Large Synoptic Survey Telescope (LSST)
Data Management

Proposed Modifications to Solar System Processing and Data Products

DMTN-087

Version	Date	Description	Owner name
1	2018-06-22	2018 Review Release.	Mario Juric
2	2019-07-XX	Serving as RFC/LCR summary.	Mario Juric

FIGURE 2: A simplified view of nightly production of Solar System related products, with orbit catalog generation and curation performed by the Minor Planet Center. A detailed workflow can be found in Figure 6 of LDM-151.

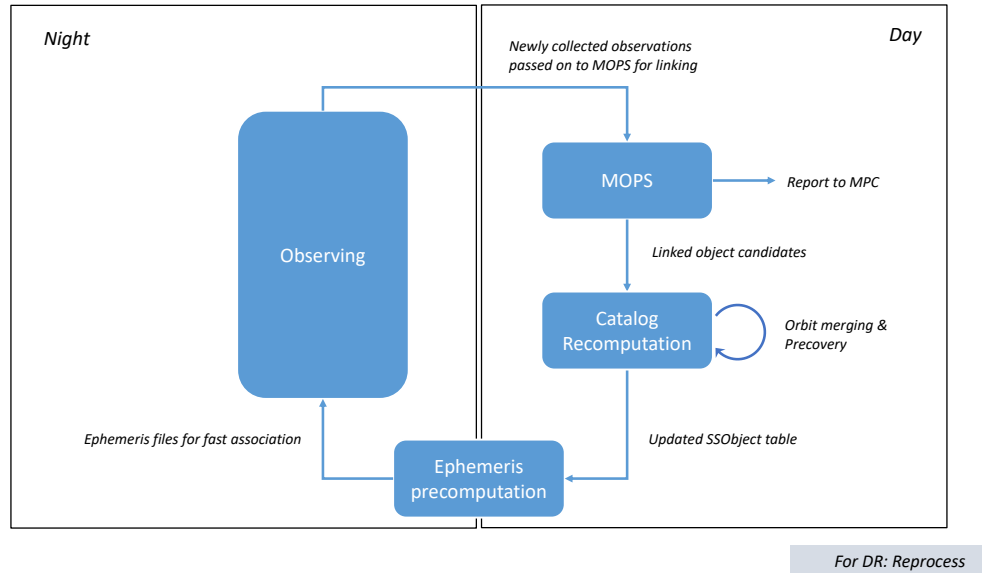
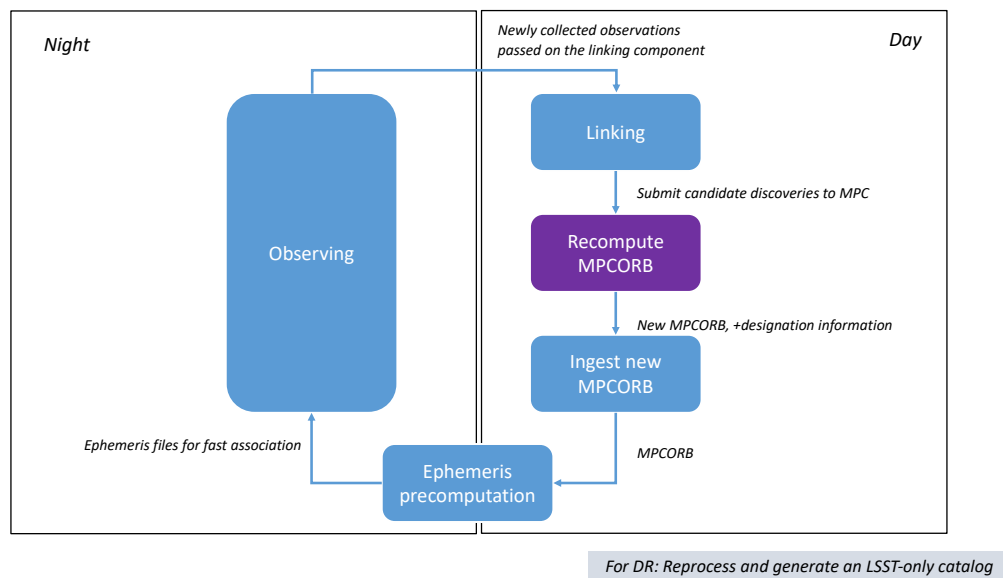
We've therefore examined the elements in Figure 1 with the aim of bringing LSST Solar System processing closer to present day practices that utilize Minor Planet Center services. There are two major sources of Solar System-specific pipelines (in terms of construction and operations effort):

The second step – construction and maintenance of the orbit catalog – is an example of "bread and butter" operation that the MPC specializes in. If the LSST delivered a list of already linked tracklets, the MPC has the software, staff, processes, and capabilities to ingest them, verify the linkage, add them to the orbit database, and perform all the typical curation activities. Assuming MPC services are used for this step, the resulting daily cycle is presented in Figure 2.

By switching to the scheme presented in Figure 2, the newly discovered high-confidence tracks would now be submitted to the MPC for inclusion into the central orbit database they maintain and regularly curate. Following incorporation of nightly data received from the LSST and other surveys, the MPC would publish an updated orbit catalog in time for the next night of LSST observing. The LSST would download the published catalog, and use it for attribution of known objects in the following night.

FIGURE 3: Comparison of present data products baseline, and the proposed changes. See text for details.

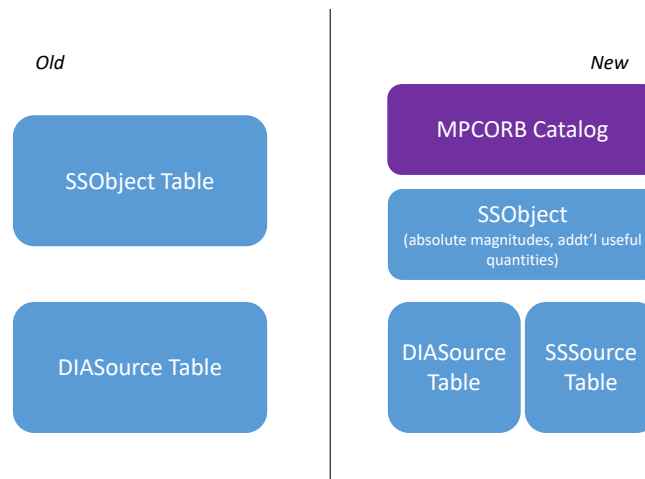
From the data products point of view, the change can be viewed as having an SSOBJect table divided into two parts: dynamical and physical characteristics. The dynamical characteristics (orbital elements) would now be computed by the Minor Planet Center (the "MPCORB" catalog); the LSST would ingest a new copy of the MPCORB every evening. We note that this means that **the orbits in the ingested catalog will be computed using not only LSST observations, but also other observations the MPC has access to**. The biases, selection function, and the quality of orbits in the catalog will therefore be complicated, making this catalog unsuitable for population studies. The DRP catalogs (see below) should be used for this purpose.

Given that information, the physical characteristics such as absolute magnitudes would still be computed by LSST (also on a nightly basis, forming the updated SSOBJect table). This is schematically illustrated in Figure 3.

The high-level table schemas in the DPDD have been updated consistent with Figure 3 to explicitly call for three tables related to Solar System objects: the MPCORB table (with orbits received from the MPC), the SSObject table (with physical quantities computed from LSST observations), and SSSource tables (with per-observation quantities).
